APPLICATION FOR ZONING RELIEF AND CERTIFICATE OF APPROPRIATENESS HISTORIC CONSERVATION BOARD PUBLIC HEARING STAFF REPORT

APPLICATION #: ZH20180193/COA2018081
APPLICANT: City Studios
OWNER: Urban Sites
ADDRESS: **528 E 12th Street**
PARCELS: 075-0003-0132, 0133, 1034
ZONING: CC-P
OVERLAYS: Over the Rhine Historic District
COMMUNITY: Pendleton
REPORT DATE: December 7, 2018
HEARING DATE: December 17, 2018
STAFF REVIEW: Beth Johnson, Urban Conservator

The applicant is requesting three variances and a Certificate of Appropriateness for construction of a new mixed use 5 story building at 528 E 12th Street.

**BUILDING SITE
PROPOSED SITE PLAN (1/16" = 1'-0")**

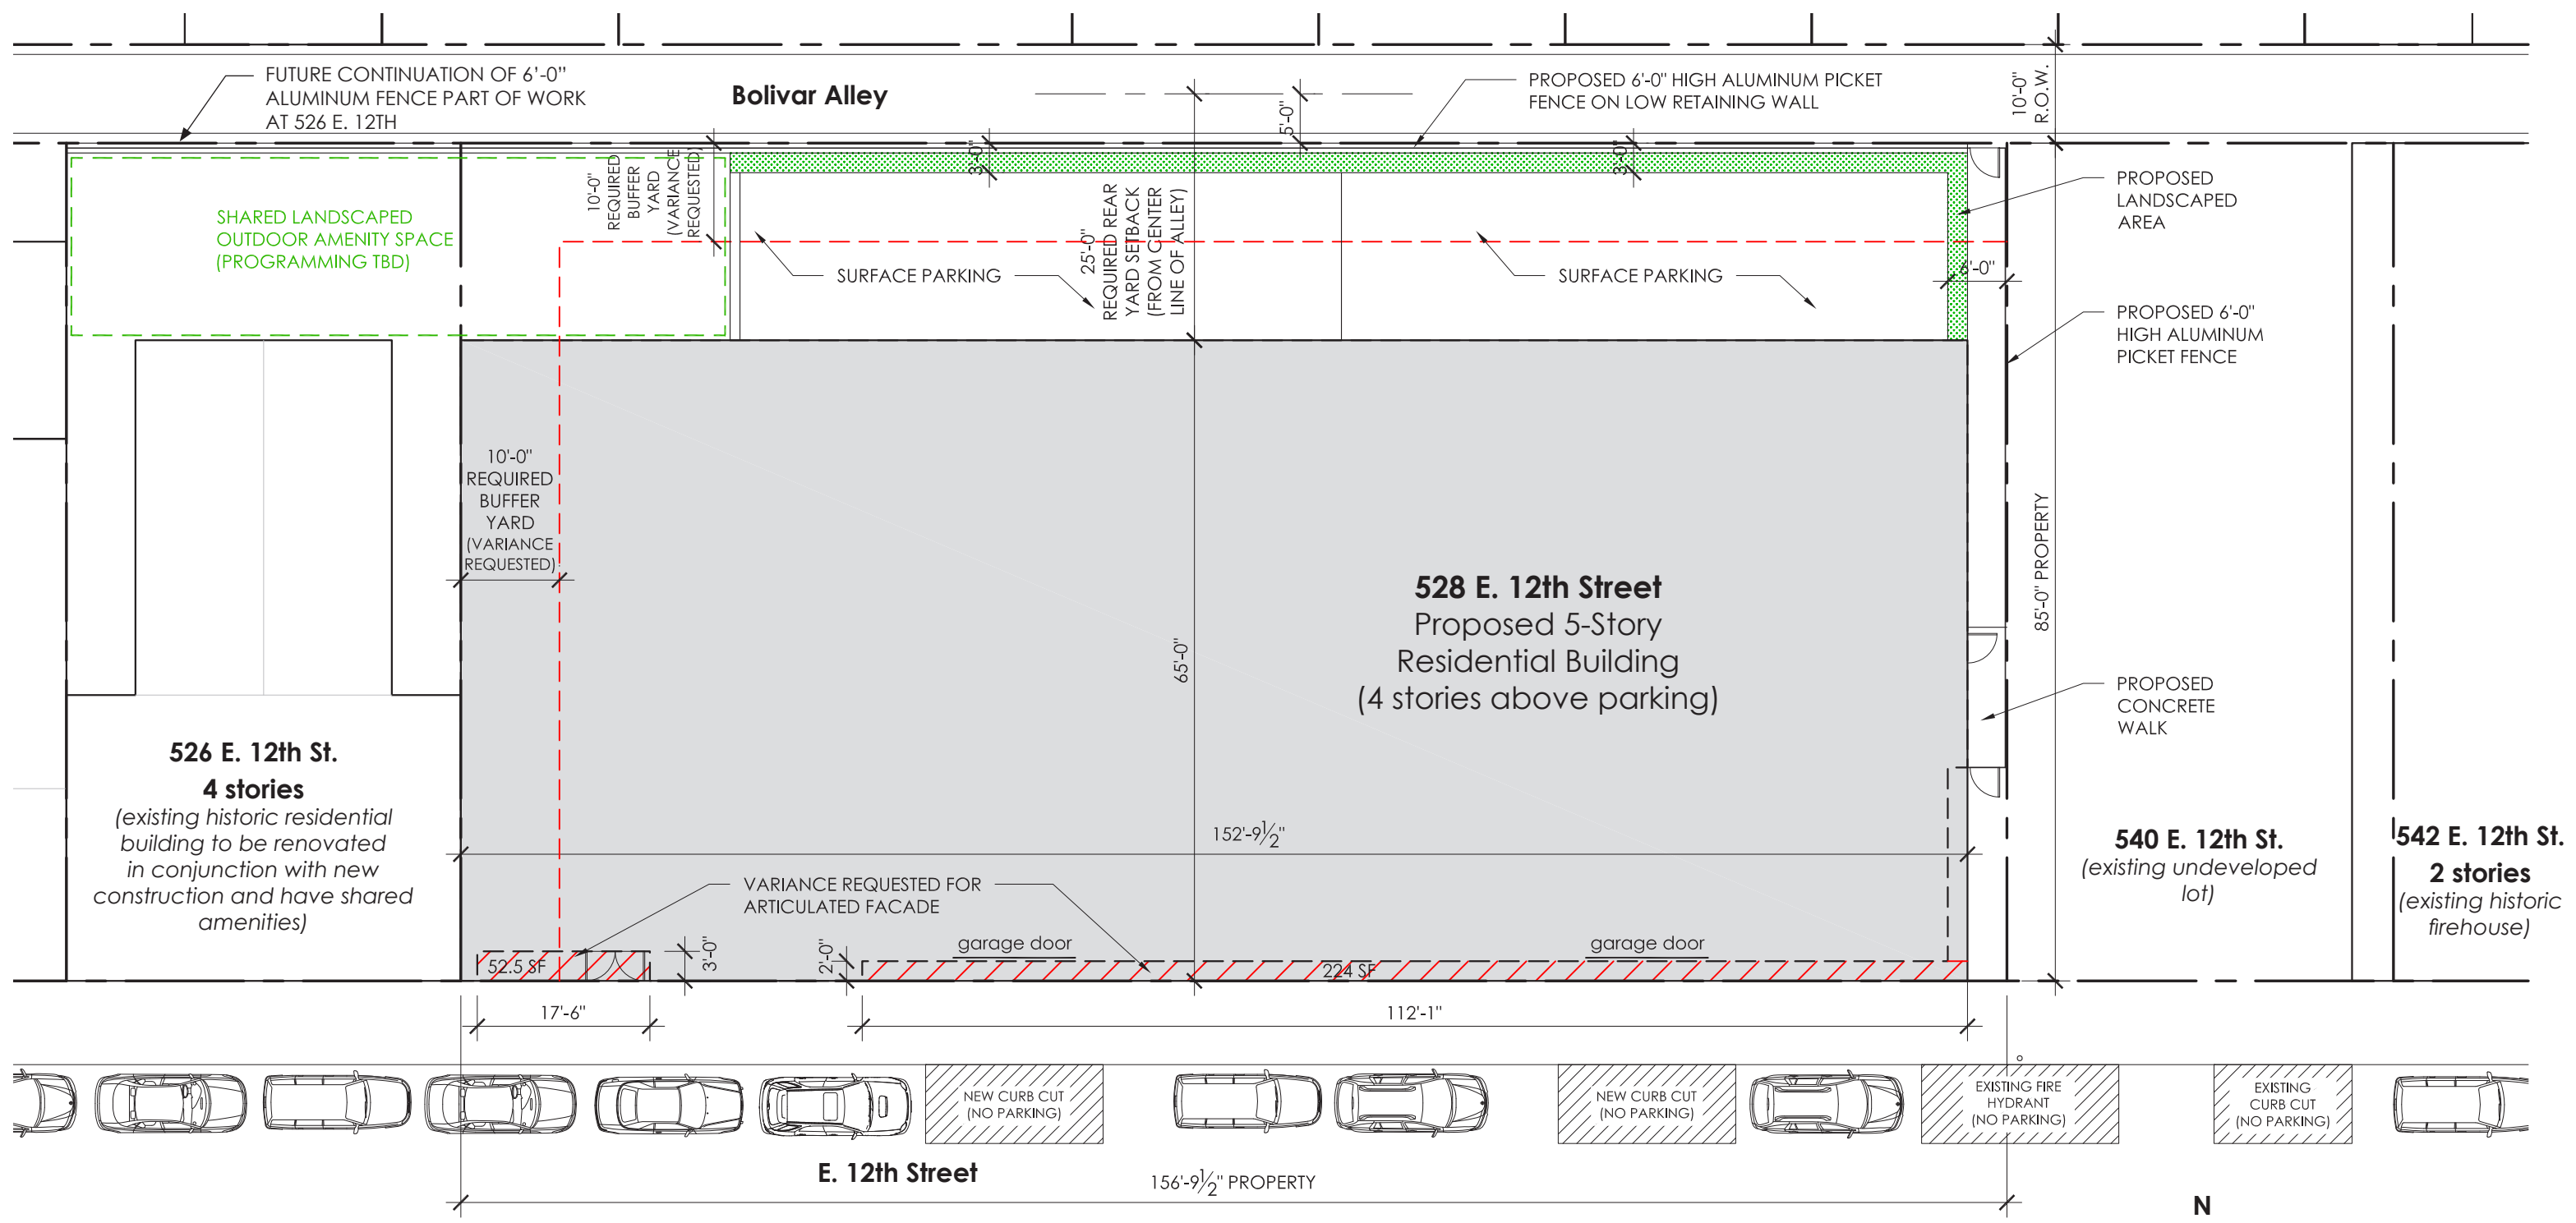
The project site is within the CC-P zoning district and is directly adjacent to RM districts on the west and north parcel lines. The properties in the RM zones do not comply with the base zoning setbacks and are historic buildings. The OTR and Pendleton Neighborhoods are typically zero side lot line developments with little to no setbacks within the district. While there is a change in zoning between two parcels along the street, it is still one continuous street face and adding a 10 foot side yard buffer would be inappropriate and would take away from the street continuity. Additionally, the proposed use, being an entirely residential use, is more in keeping with the requirements of the RM district as it provides no commercial uses within the development, nor makes it practical that any future commercial use could be established. Thus, the need for buffering of identical uses becomes a true question of necessity. Had a proposal been forwarded that contained any commercial and industrial uses as the existing site does, then buffering of storage areas and screening of outdoor nuisances would be necessary. Buffering a few parked cars, located well below their northern neighbors yards and hardly visible but for standing at the rear property line and looking downward, requires little if any visual and spatial barriers.

The lesser rear buffer variance is acceptable as this buffer is not created with other properties in the CC-P along 12th street to the RM district to the north. The applicants are asking for a similar right. It should be noted that a portion of the property does in fact provide a 10 ft. buffer, while the remainder maintains 3 ft. of unpaved area.

5. **Buffering.** Appropriate buffering is provided to protect adjacent uses or properties from light, noise and visual impacts.
The applicants are asking for a variance for buffering on the side and rear. Staff support for this is discussed above.

A variance is being requested to reduce the buffer zone at the rear of the property. The plans show most of this area being used for exterior parking on a concrete pad which will be viewed from the existing buildings to the North and the new residential units above. This leaves very little room for landscaping and ways to make this area pleasant and attractive.

- a. Planters and benches will be provided at the front of the building as indicated on the approved plans.
3. **§1423-13- Numerical Variance: APPROVE**– 10 foot numerical variance to allow a 0 ft. buffer on the west side parcel line and 7 ft. buffer on the rear parcel line with the conditions the site plan with landscaping at the rear match the approved site plan.

BUILDING DESIGN STREET CONTEXT

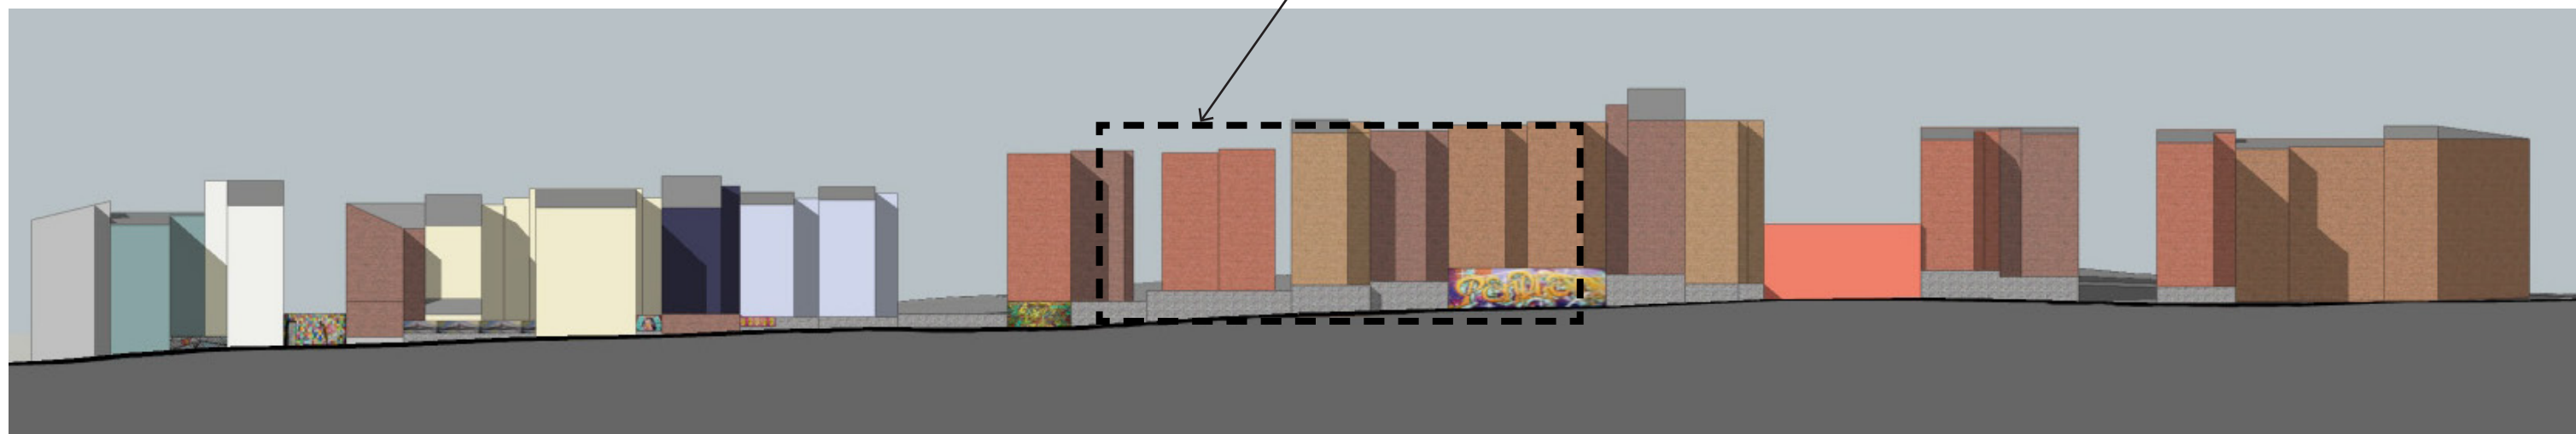
There are not anticipated any adverse effects to the extent of access to fire, police or other public services. In regards to concerns from neighbors on 13th Street that views could be impacted from their property, the underlying zoning district allows for an 85 foot tall building and the Historic District guidelines allow for a height to be within 1 story of adjacent "Contributing Structures". The proposed building is 56'8", well below the allowed maximum height of the zoning district and at 5 stories only 1 story greater than the contributing 4 story structure adjacent to the west. East of the site, is immediately vacant, with a two story contributing structure on the eastern half of the property; a firehouse and former municipal structure that would functionally not have ever been considered taller than it was built. The last structure on the street is two stories. Structures to the north are 4 and 4 ½ stories in height and are ½ story to 1 ½ + stories higher in grade than the proposed grade of the project. While the height of the building is also addressed within the Certificate of Appropriateness guidelines, staff recommends that the height is appropriate.
